Standards Governing the Design of Curbside Mailboxes

ACTION: Final rule.

SUMMARY: The Postal Service is replacing USPS STD 7B, which governs the design of curbside mailboxes, with

U.S. Postal Service Standard 7C

TRADITIONAL MAILBOX
 FIGURE 1A

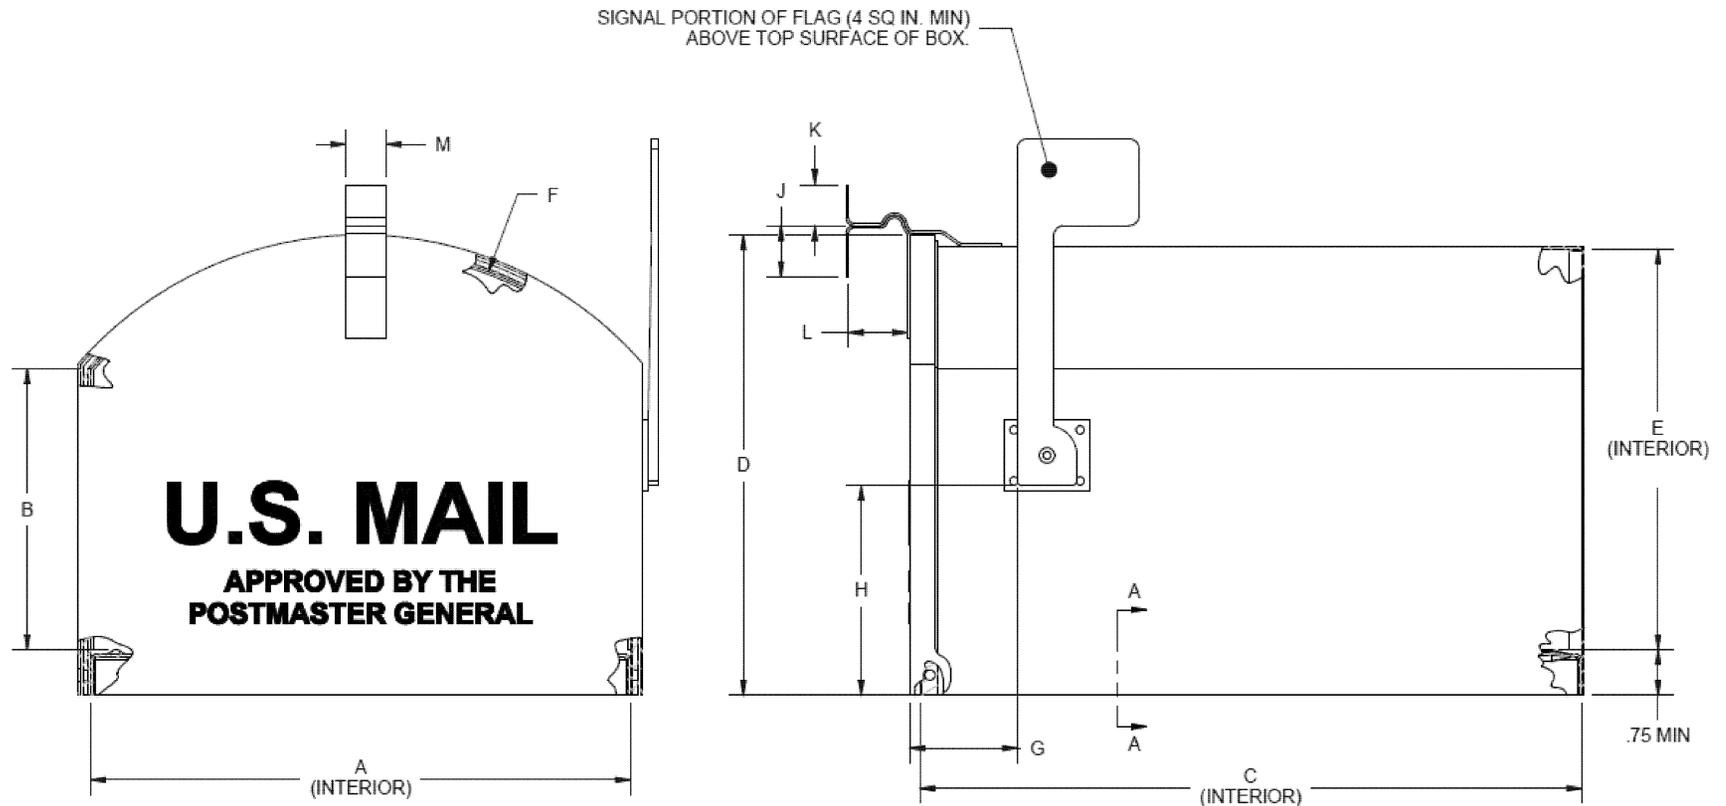
These comments also suggested the need for clarification of the requirements concerning the flag dimension for traditional mailboxes in Figure 1A, and more specificity regarding the requirement in section 3.9 that the color of the flag present a “clear contrast” with the predominant color of the mailbox. These suggestions were not accepted. We believe that such changes to longstanding requirements for boxes already approved under former STD 7B would not be appropriate in this context.

HANDLE/KNOB DESIGNS
FIGURE 5

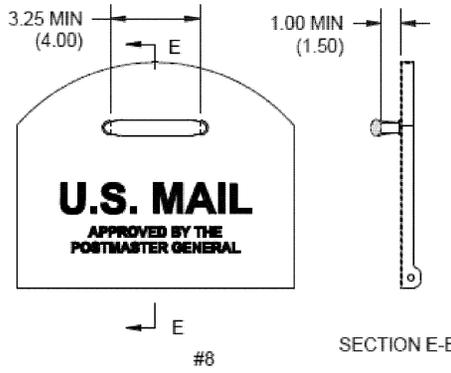
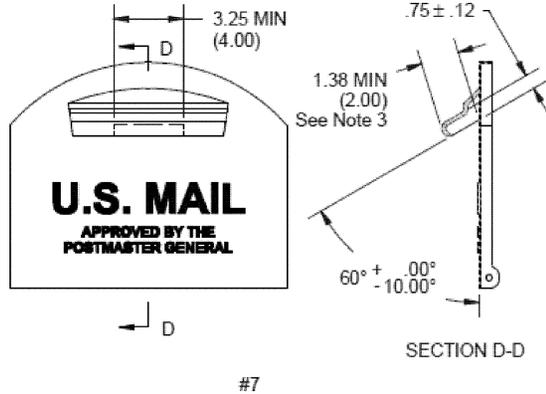
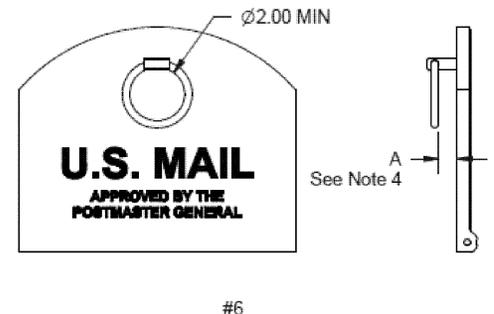
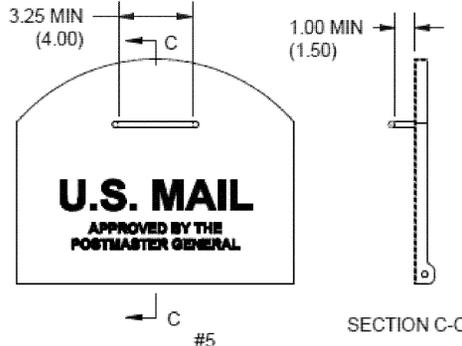
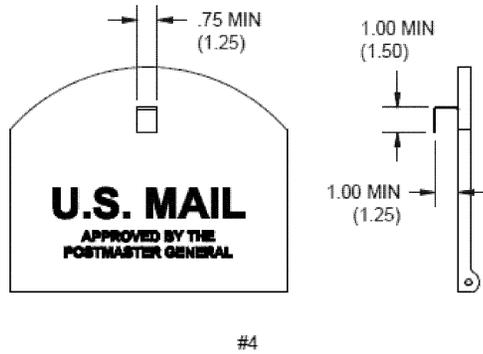
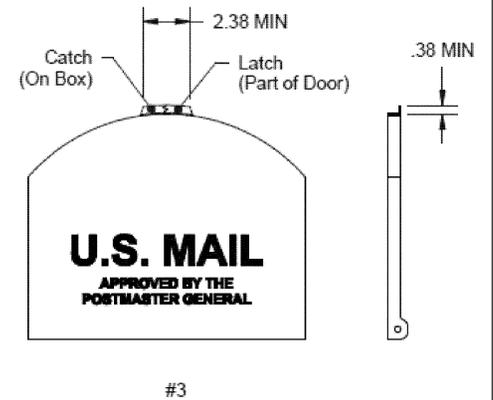
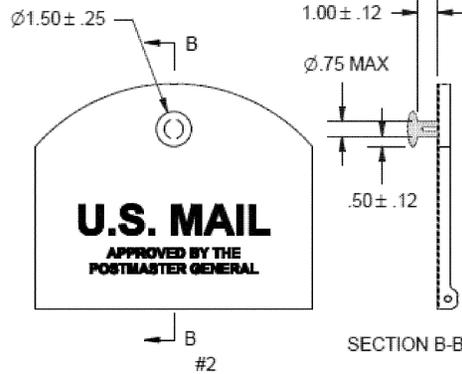
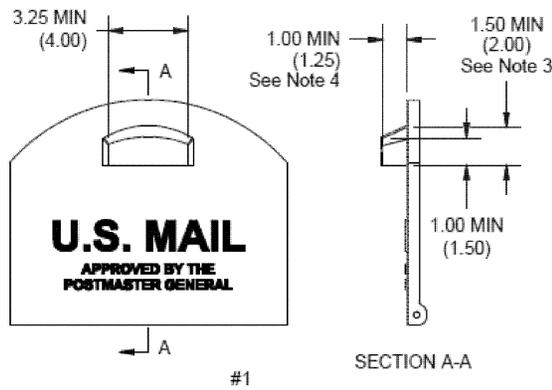
This set of comments also questioned the width of the mailbox door handles

shown in design Figure 5 of the proposed standards, and suggested that they reflected a change from the current standards of USPS STD 7B. No such dimensional changes were intended, and Figure 5 has been reworked accordingly.
